Exterior Renovations
at

Cascadian Apartments 15517 NE 12th St., Bellevue WA 98007

February 23, 2024

ADDENDUM NO. 1

P-S203

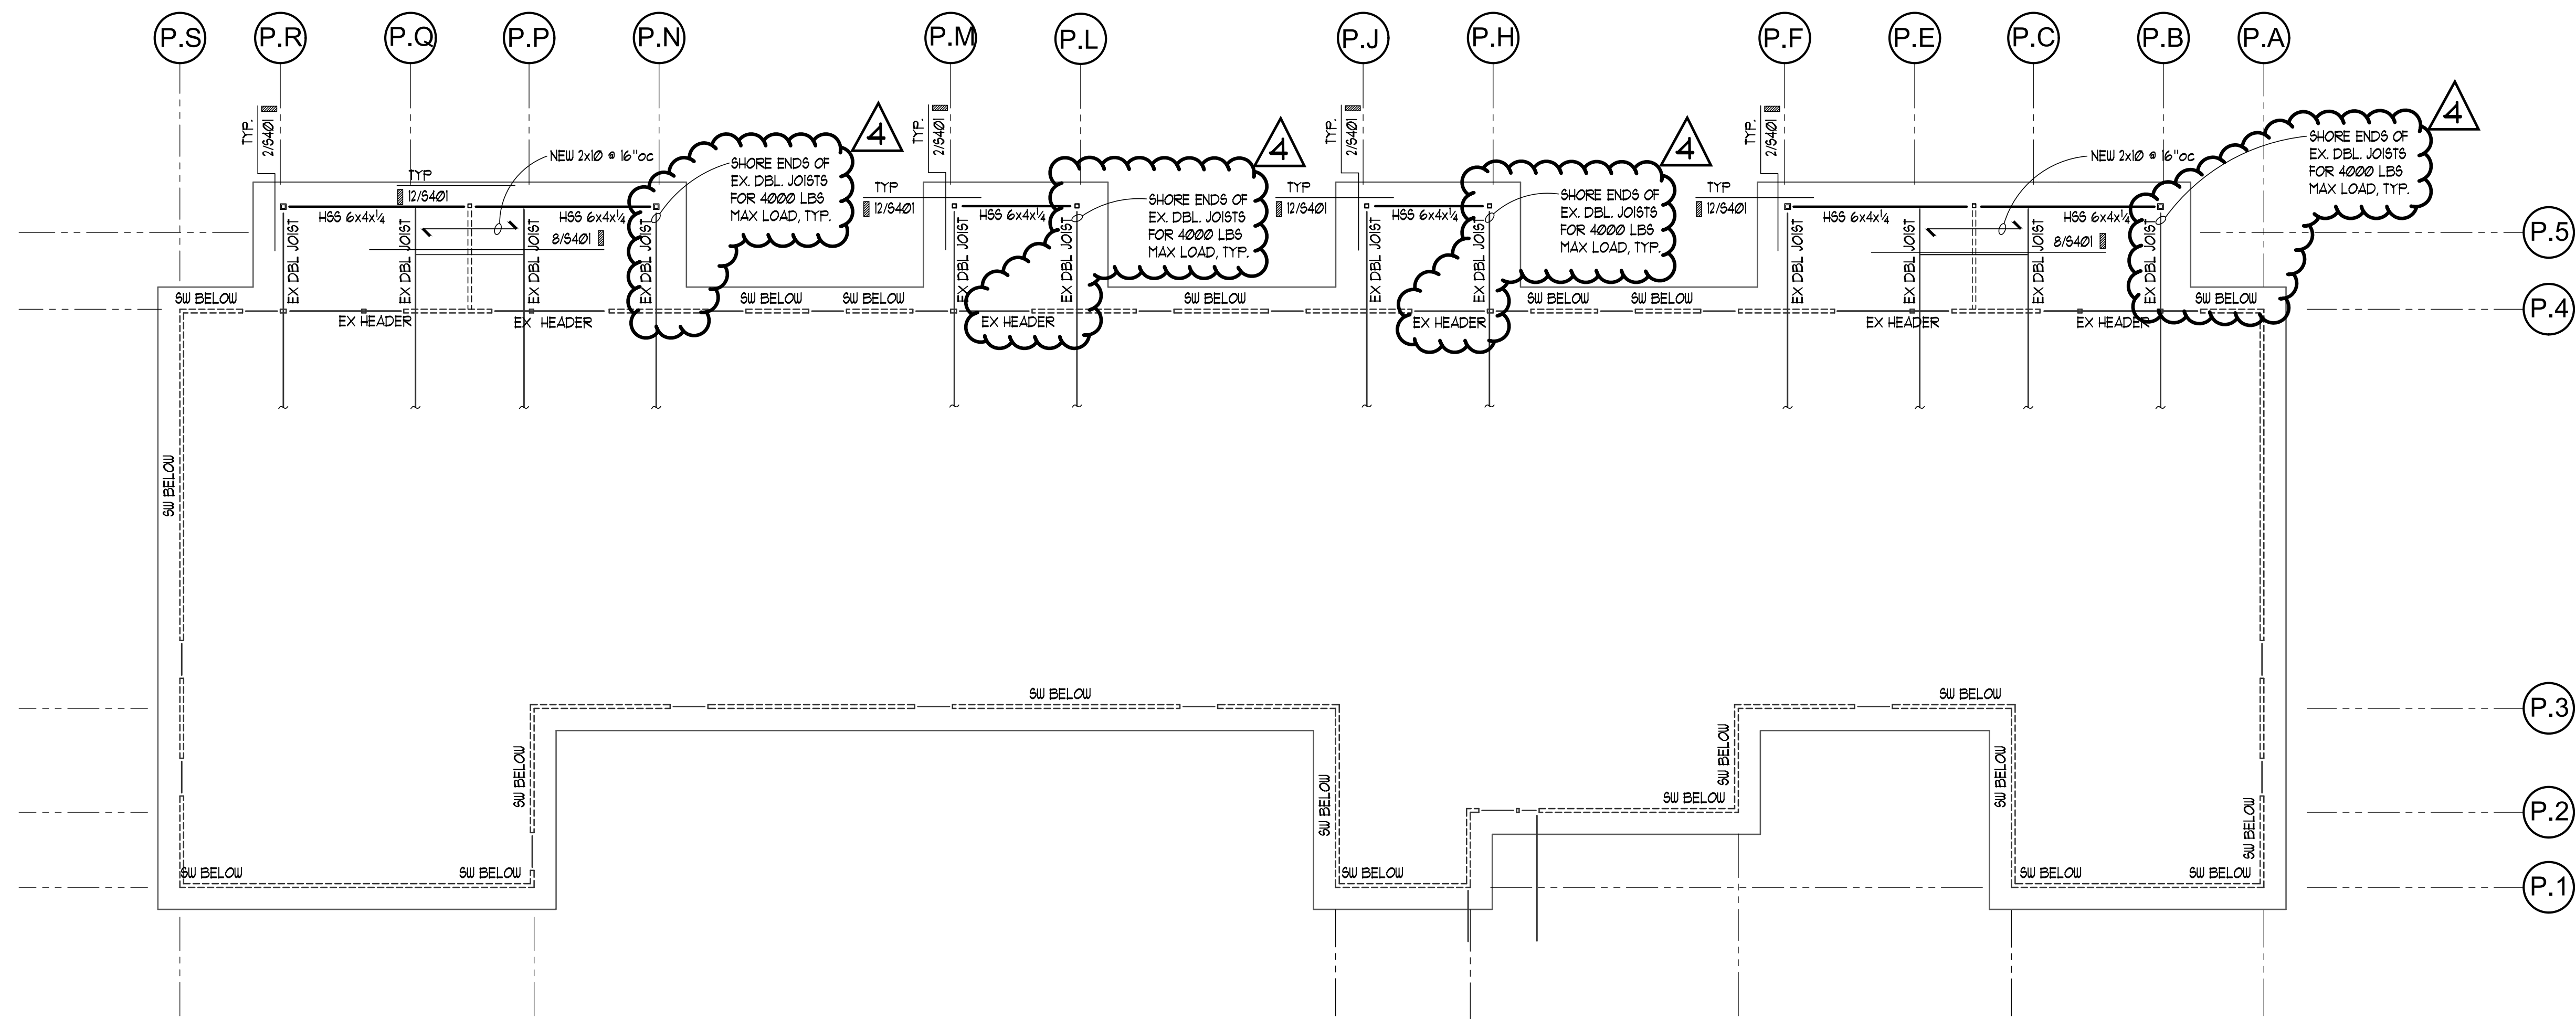
Q. 2. Roof Shoring- Do you have a shoring detail on how you want these roofs shored while decks are being rebuilt?

A. See revised sheet S203 for Structural notes on roof plan and leader indicating required loads for contractor to provide shoring as Means and Methods.

2 TYPICAL TURNED DOWN SLAB EDGE

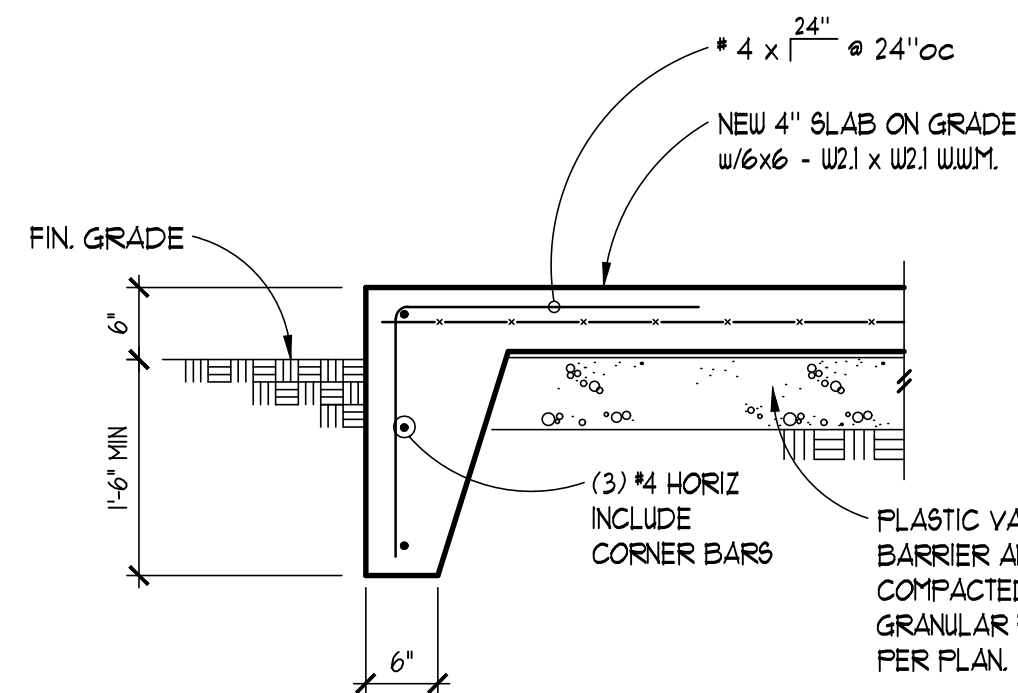
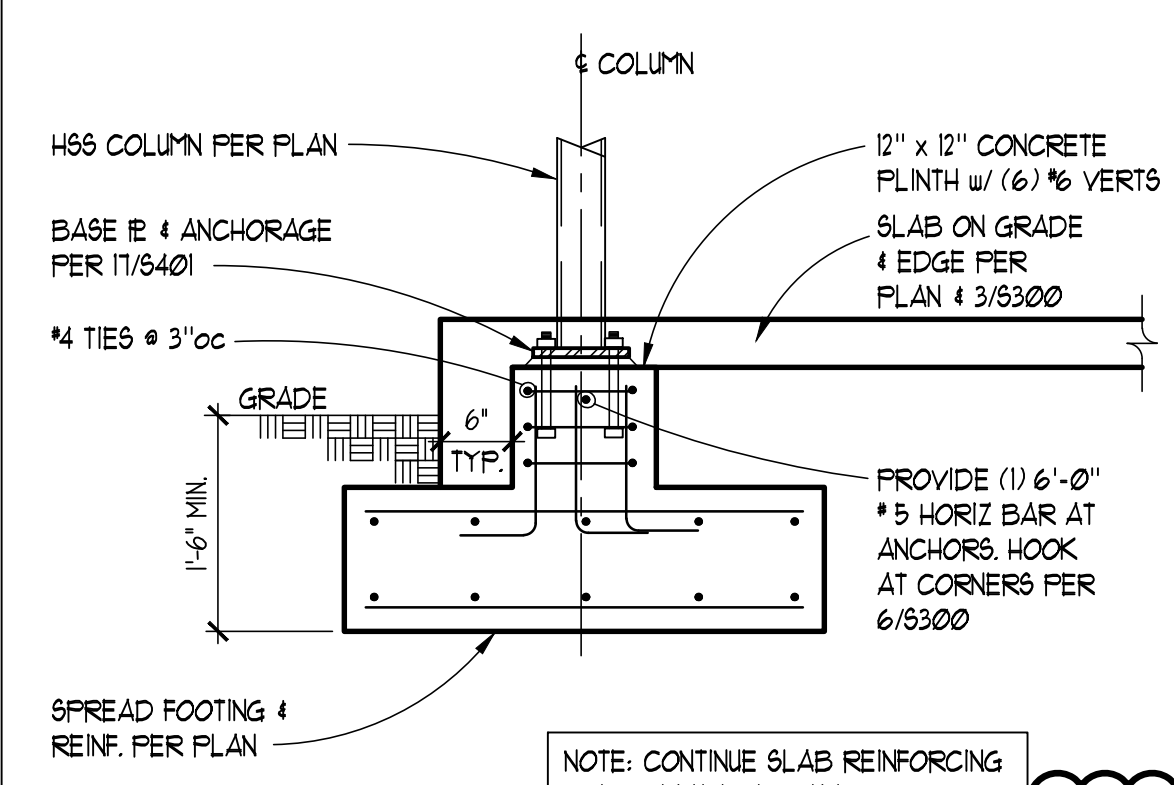
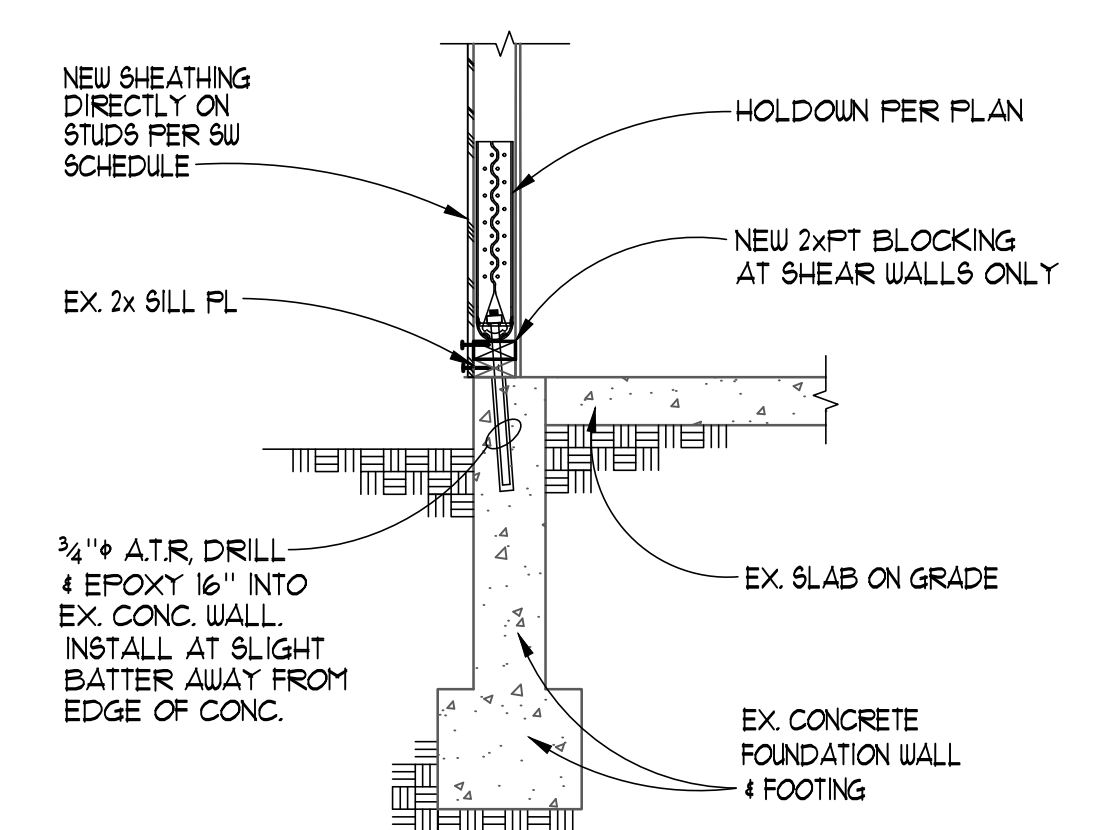
Sheet N-S200 Plan view shows a solid black line outside of the HSS Columns, noting detail 3N-S300. Detail 8N-S300 shows the turned down slab edge, pouring to the backside of the steel HSS columns, sitting on top of the spread footing.

What's the design intent, are we to pour the turned down slab per detail 8N-S300 to the back side of the HSS column?

A. See revised sheet S200 and S300 for Structural details.
